**RAI Volume 3, Chapter 2.2.1.3.5, First Set, Number 2:**

**RAI Volume 3, Chapter 2.2.1.3.5, First Set, Number 4:**

Figure 1. Comparison of Recharge Estimates for All Models and Data from Infiltration Report (SNL 2008) with MASSIF Model Results

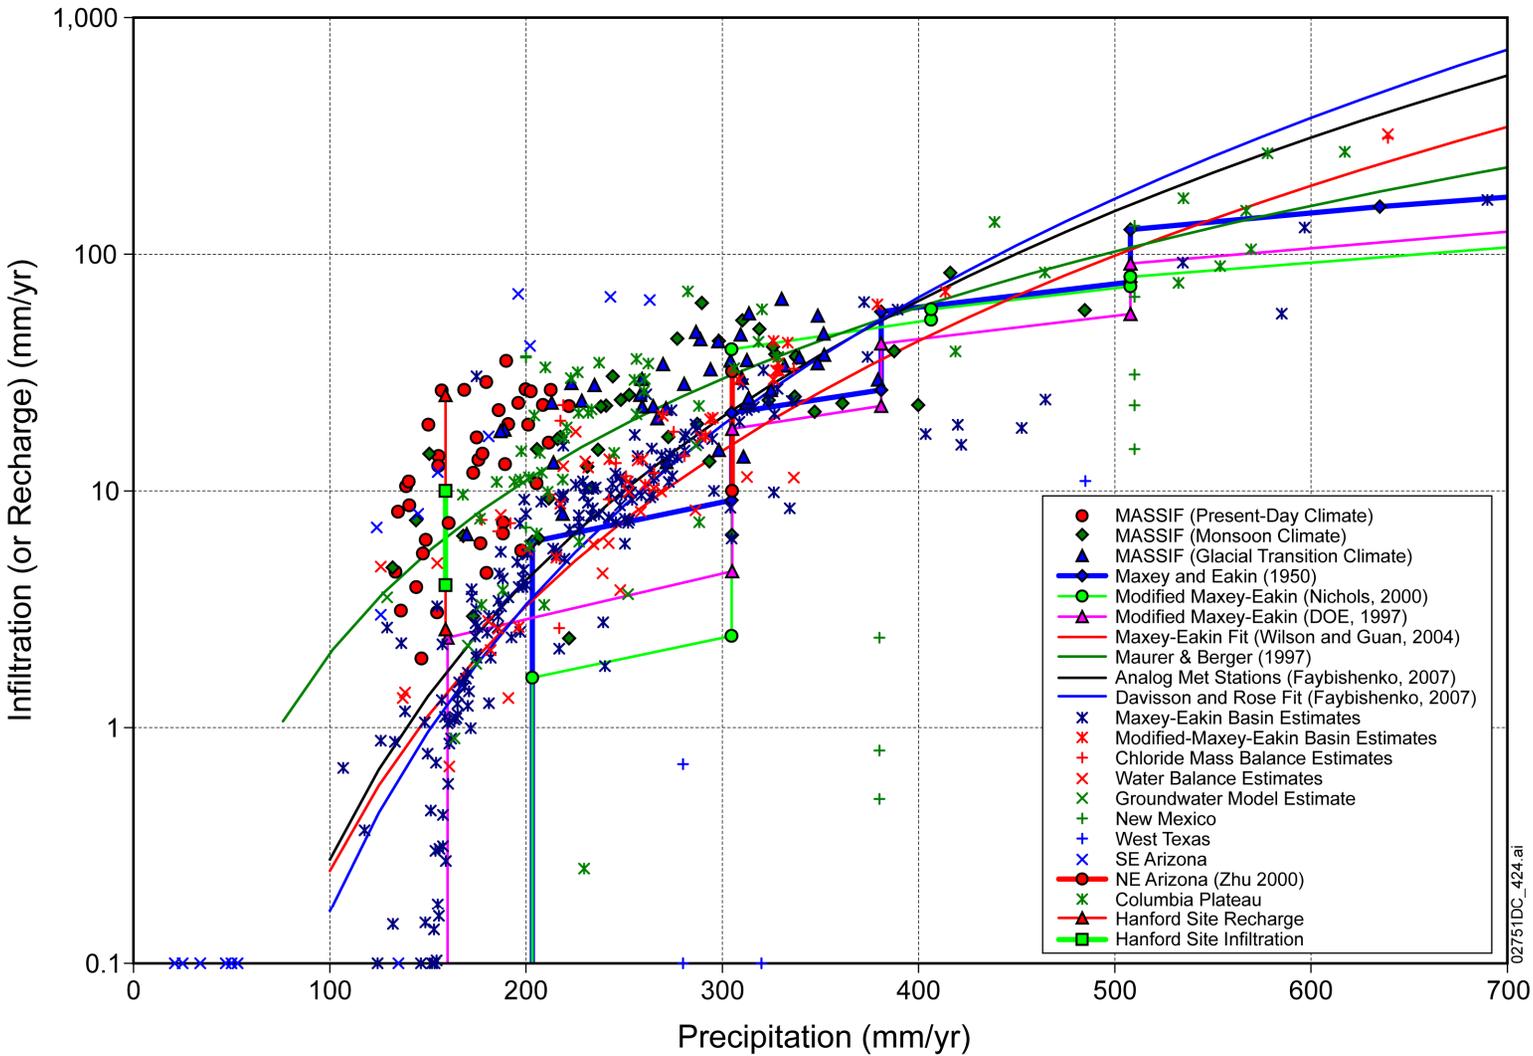
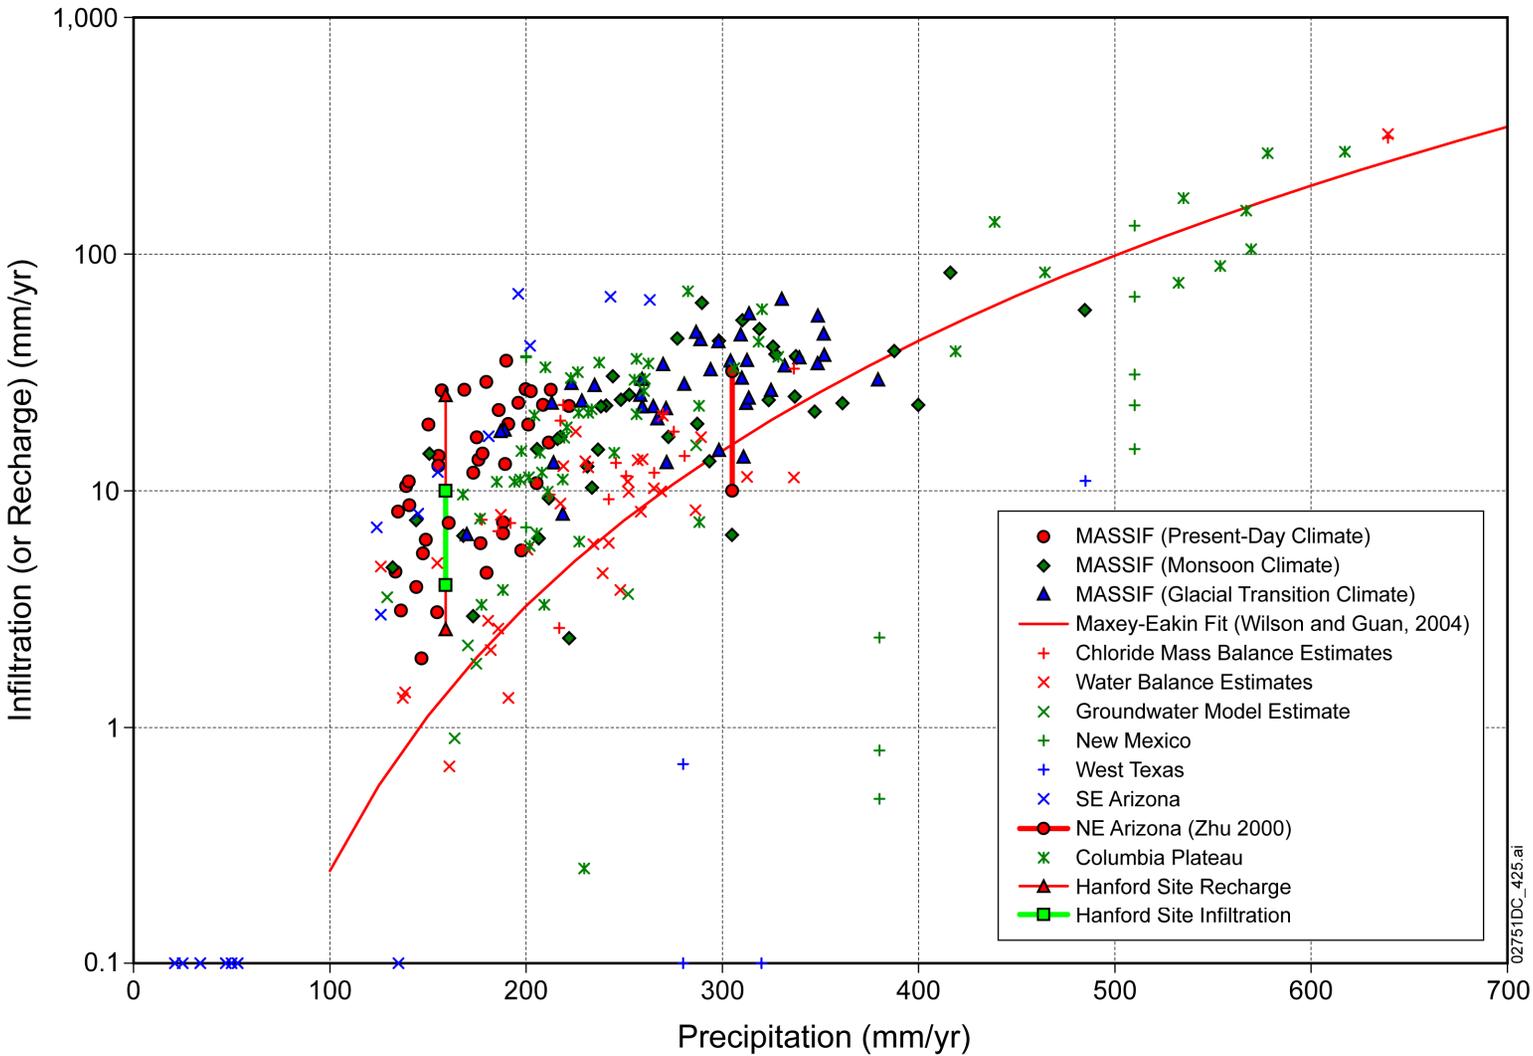
Explain why the infiltration model results appear to be less sensitive to mean annual precipitation than indicated in the supporting information used for post-model-development validation (e.g., SAR Figure 2.3.1-48). This information is needed to evaluate compliance with 10 CFR 63.114(a)(7).

Basis: Power law relationships between mean annual precipitation (MAP) and mean annual infiltration (MAI) from various researchers are reported in SAR Figure 2.3.1-48. The Wilson and Guan (2004) linearization of the Maxey Eakin relationship and the Faybishenko (2007) relationship between climate and infiltration (based on the meteorological stations used in the SAR to represent climate states) imply a rate of increase in MAI with respect to MAP. Using these relationships to scale the present day MAI values from SAR Table 2.3.1-2 implies that the monsoon and glacial transition values of MAI would be approximately 3 times larger than the values in SAR Tables 2.3.1-3 and 2.3.1-4. It is not clear why the MASSIF infiltration model does not exhibit a similar sensitivity to climate as these relationships.

While the Mass Accounting System for Soil Infiltration and Flow (MASSIF) infiltration model results appear to be less sensitive to mean annual precipitation (MAP) than six of the seven comparison models used for model validation as presented in SAR Figure 2.3.1-48 alone, comparison of MASSIF results to a significant set of analogue data indicates reasonable agreement of MAP and mean annual infiltration (MAI) relationships. These seven comparison models are: the original Maxey-Eakin model (1950), two modified Maxey-Eakin (MME) models (DOE 1997; Nichols 2000), the Maxey-Eakin fit of Wilson and Guan (2004), two empirical models of Maurer and Berger (1997) and Faybishenko (2007), and the MAP/MAI equation attributed to Davisson and Rose in Faybishenko (2007). As discussed in SAR Section 2.3.1.3.4.2.2, the empirical model of Maurer and Berger (1997) represents MAP versus water yield, where water yield equals subsurface flow plus surface runoff, so it is not directly comparable to the MASSIF model results.

The model validation discussed in the infiltration model report (SNL 2008) provides a thorough set of comparisons, using a variety of methods, between the MASSIF model results and other researchers' models and data for sites in Nevada, the southwestern United States (New Mexico, west Texas, and southeast Arizona), and on the Columbia Plateau (centered in southeast Washington state). These comparisons are presented in Figures 7.2.1.2-1[a], 7.2.1.2-2[a], 7.2.1.2-3, and 7.2.1.2-4[a] of the infiltration model report (SNL 2008). All data from these four figures have been compiled into Figure 1 for this RAI response.

Figure 2 is similar to Figure 1, except that the Maurer and Berger (1997) model and all but one of the other six empirical models have been deleted, leaving only the Wilson and Guan (2004) fit of the Maxey-Eakin model for reference. All published data points using the Maxey-Eakin and MME methods have also been removed in Figure 2. Figure 2 reveals that the MASSIF model

results are fairly consistent with the range and trend of scatter of MAI/MAP data points. Figure 2 suggests that the MASSIF model results are corroborated by a variety of infiltration estimates including chloride mass balance estimates, water balance estimates, and calibrated model estimates. While the Maxey-Eakin and MME models are useful for comparison due to the historical significance of the well-recognized and nearly 60-year-old Maxey-Eakin model, comparison of Figures 1 and 2 suggests that the Maxey-Eakin and MME models appear to generally underestimate MAI at MAP values less than 300 mm/yr when compared to other published infiltration and recharge estimates for the western U.S. In addition, Figure 1 suggests that the two Faybishenko (2007) empirical models also generally underestimate MAI at MAP values less than 300 mm/yr.

Figure 1. Schematic Showing How the Uncertainty Distribution for the Upscaled Quantity of Soil Depth Is Developed

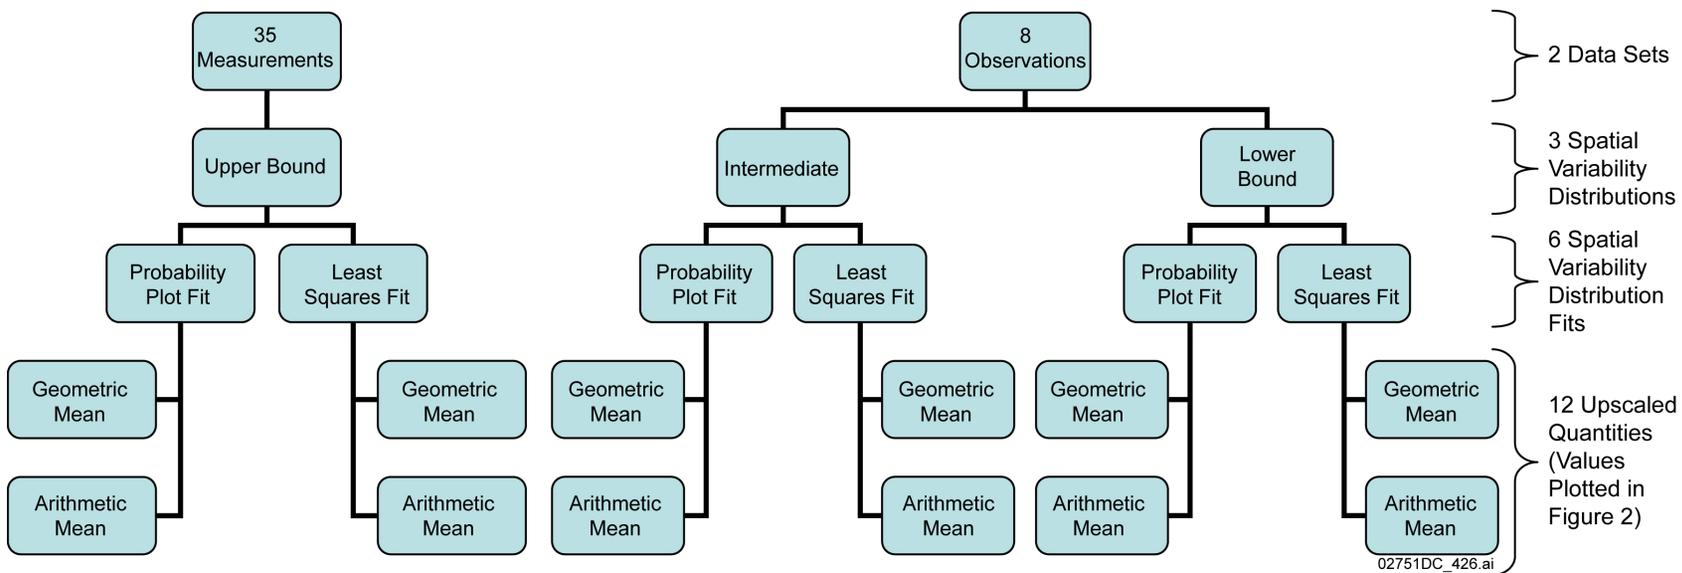
Clarify why the number of soil depth observations used to represent the range and distribution of soil depth in each soil depth class across YM is appropriate such that net infiltration is not underestimated. Of particular concern are areas with soil depth less than 0.5 m. This information is needed to evaluate compliance with 10 CFR 63.114(a)(1,2).

Three distributions were considered. Each distribution was fitted using two fitting methods: (1) least squares fit; and (2) probability plot fit. This provided six ways to estimate the upscaled quantity. As two upscaled quantities were considered (one from the geometric mean and one from the arithmetic mean), this provided 12 estimates for the representative value (see schematic in Figure 1). For each, a lower bound and an upper bound was estimated by adding or subtracting one standard error to the value (capturing the uncertainty due to the small number of photographs or measurements available in each case), which represents that value's confidence interval. The minimum and maximum values of the bounds represent the uncertainty in the upscaled quantity (SNL 2008, Tables 6.5.2.4-5[a] and 6.5.2.4-6[a]).

If any of the values of a distribution are equal to zero, the geometric mean is equal to zero. Thus, the inclusion of zero values will lead to a useless estimate. One solution is to associate a very small (constant) value to represent the fraction of the spatial distribution with zero soil depth. As the geometric mean is equivalent to an arithmetic mean calculated on log-transformed data, taking a value too small will lead again to a very low value of the geometric mean. Therefore, the presence of 1 cm of soil is essentially equivalent to no soil regarding the resulting net infiltration. The geometric mean was then estimated using log-transformed data, estimating the mean and its confidence bounds, summing 75% of these bounds with 25% of the logarithm of 0.01 m (approximately  $-4.6$ ), and exponentiating the results to convert to a linear scale. Higher values of soil depth, from 2 to 9 cm, have been tested to represent the fraction of bare rock and to estimate the sensitivity of confidence bounds to the selected values. With 10-cm accuracy, all values result in the same confidence interval (SNL 2008, Section 6.5.2.4[a], p. 6-46).

The minimum value estimate is thus set equal to 0.1 m (bounds for the geometric mean using the probability plot fitting method on the second data set using the first approach, and for the geometric mean on the second data set using the second approach). The maximum is equal to 0.5 m (upper bound of the arithmetic mean using the probability-plot fitting method on the first data set). Because there is no reason to favor any of these values (or any intermediate value), a uniform distribution for soil depths between 0.1 and 0.5 m was selected to represent the uncertainty in the upscaled quantity used to represent the effective uniform value of Soil Depth Class 4 (SNL 2008, Tables 6.5.2.4-5[a] and 6.5.2.4-6[a]).
